**REQUEST for AMENDMENT to
SITE DEVELOPMENT PLAN**

REQUESTED REVISIONS TO SITE PLAN:
△ REVISION TO PARKING AREA
△ REVISION TO BUILDING AREA

**Sandia Foundation
Used Car Dealership
San Mateo Boulevard NE
Albuquerque, New Mexico**

**AMENDMENT to
SITE DEVELOPMENT
PLAN**

A1 REFUSE ENCLOSURE PLAN
 EPC COND. #11 1/4" = 1'-0"

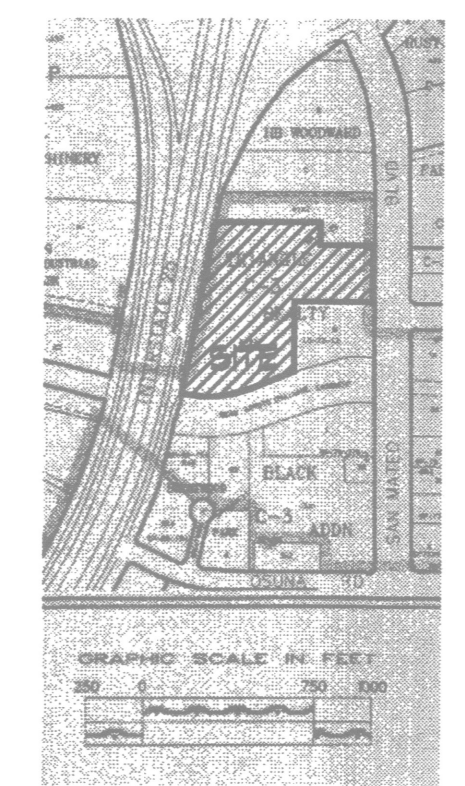
A3 TRASH ENCLOSURE ELEVATION
 EPC COND. #11 1/2" = 1'-0"

CHANGES TO SITE PLAN DUE TO E.P.C. COMMENTS OF FEBRUARY 20, 1986

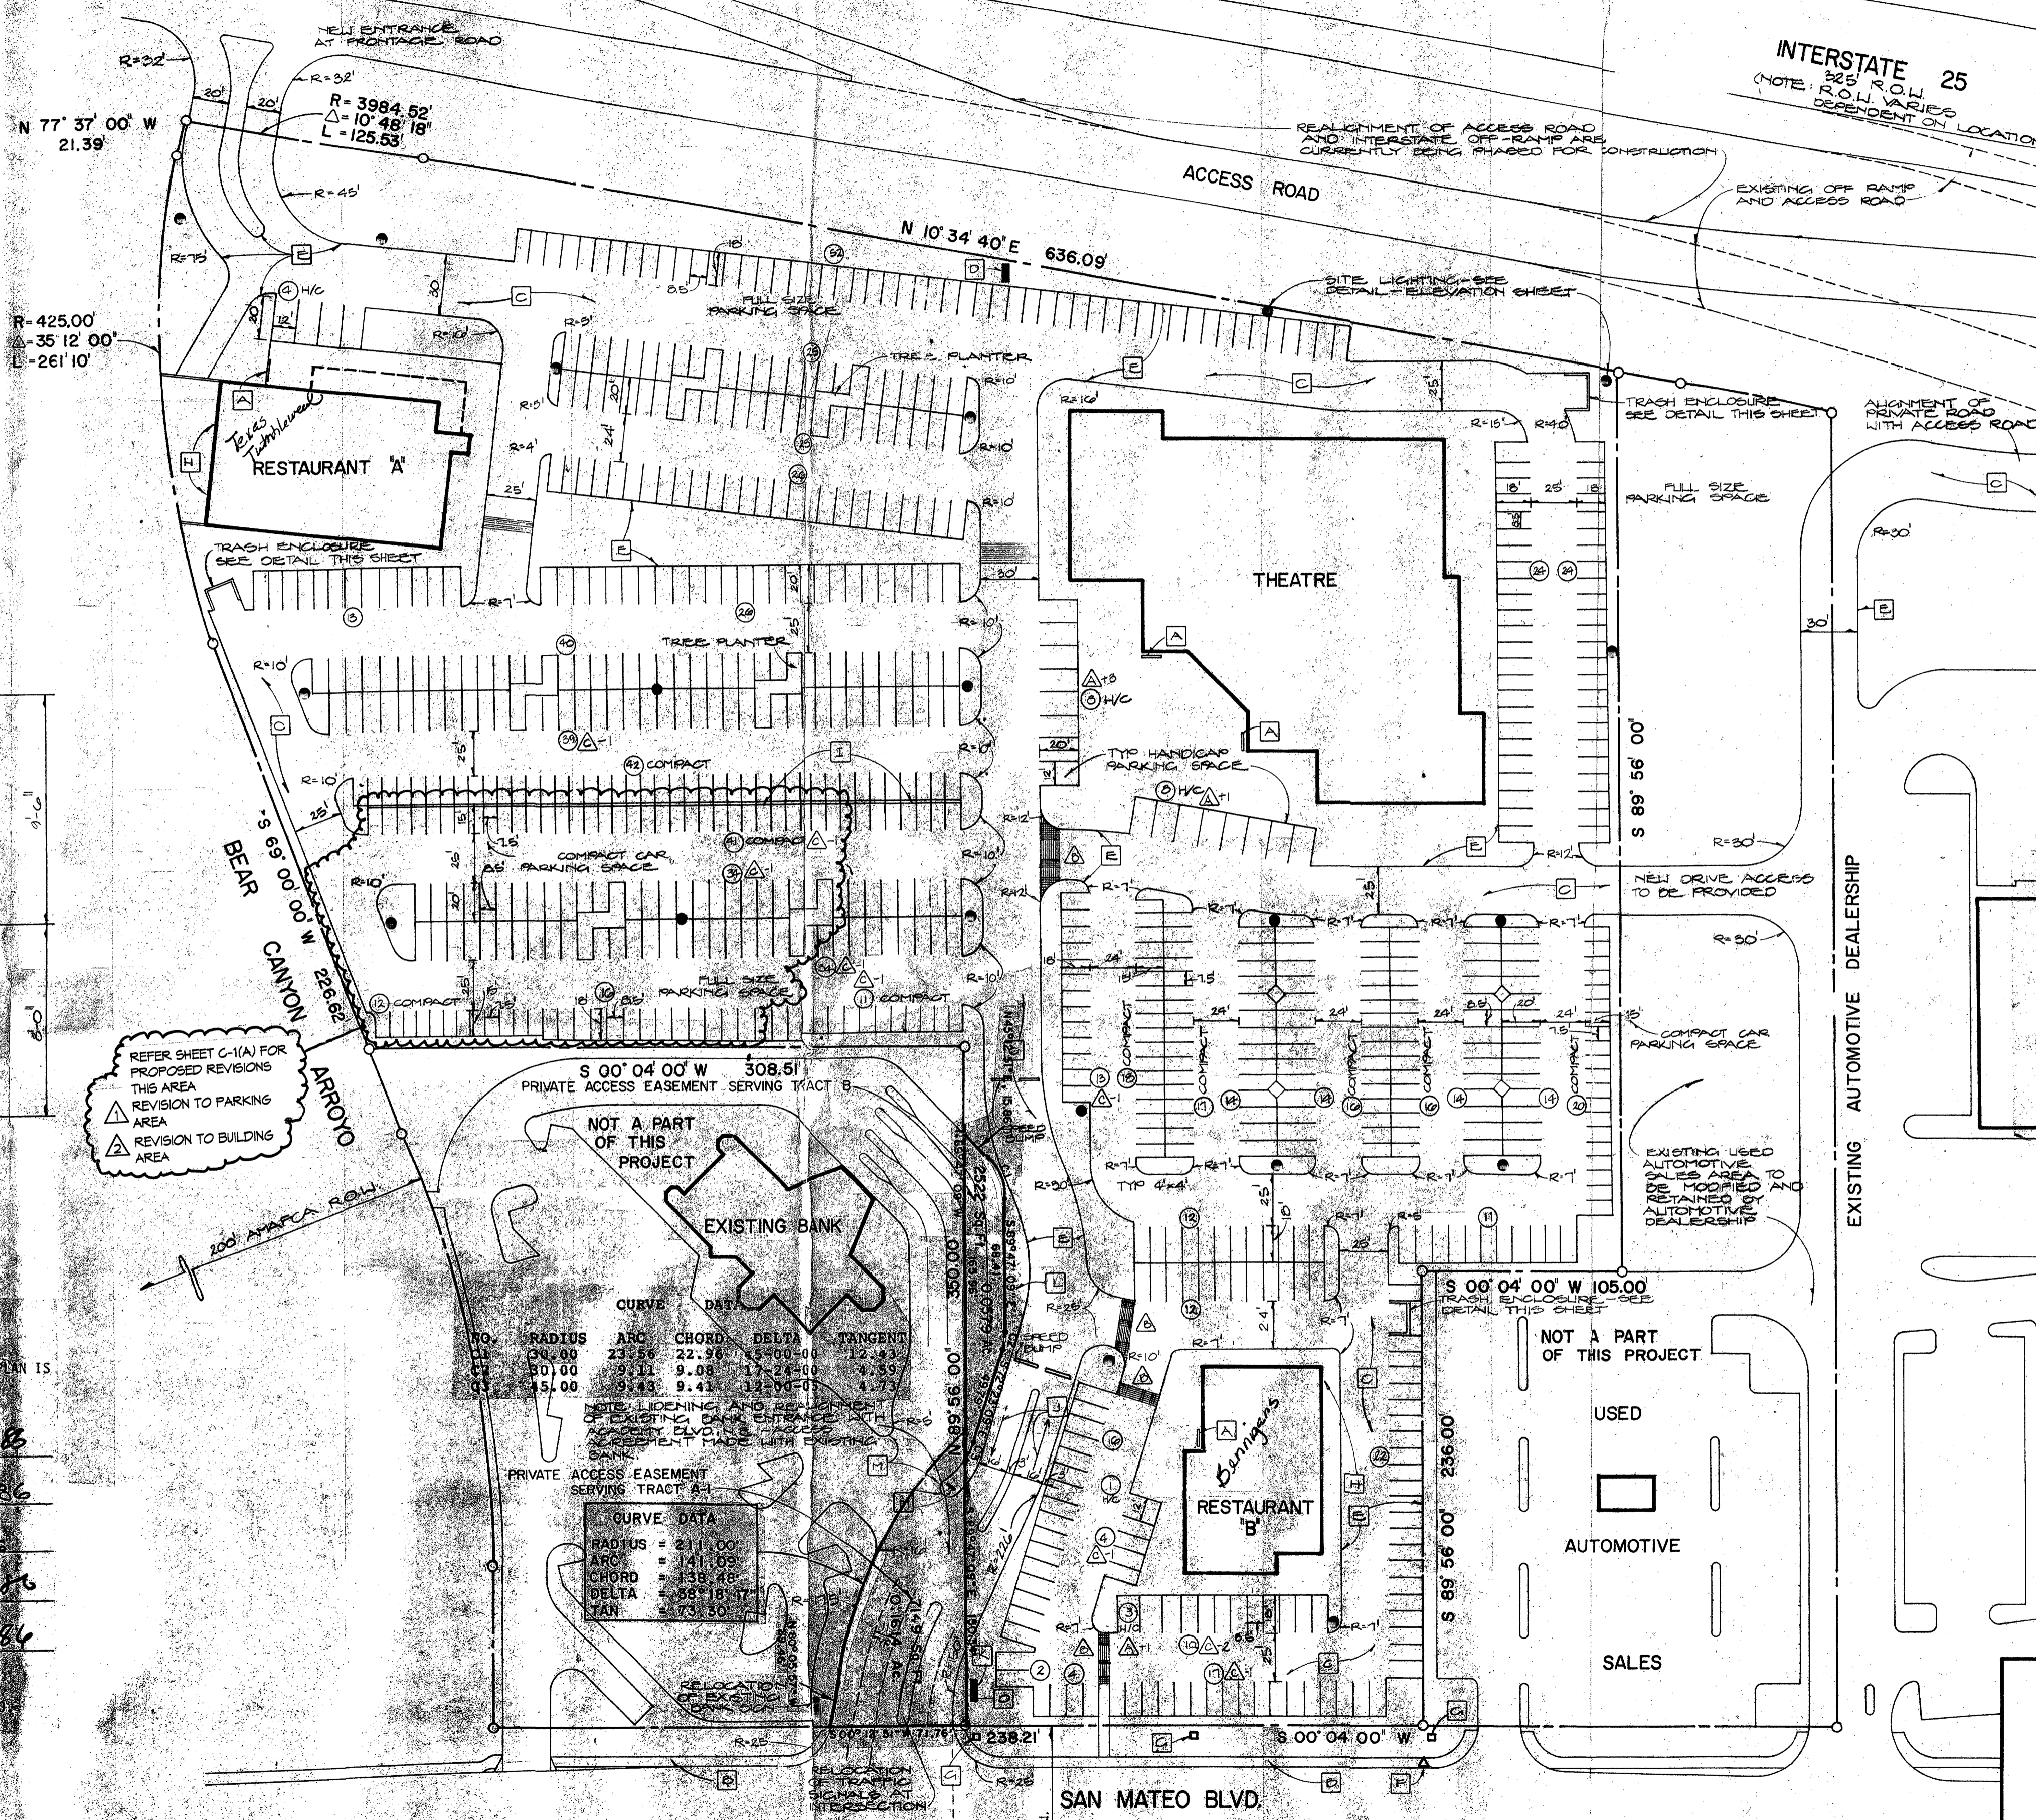
- △ Handicap parking spaces added at each building location. Additional amount designated in specific area.
- △ Improved pedestrian access between San Mateo Blvd. and restaurant B. Also, between restaurant B and the theatre. Textured walks were added (see also landscape plan for sidewalk location).
- △ Parking space reductions or additions due to the above changes and △ change amount designated in specific area.
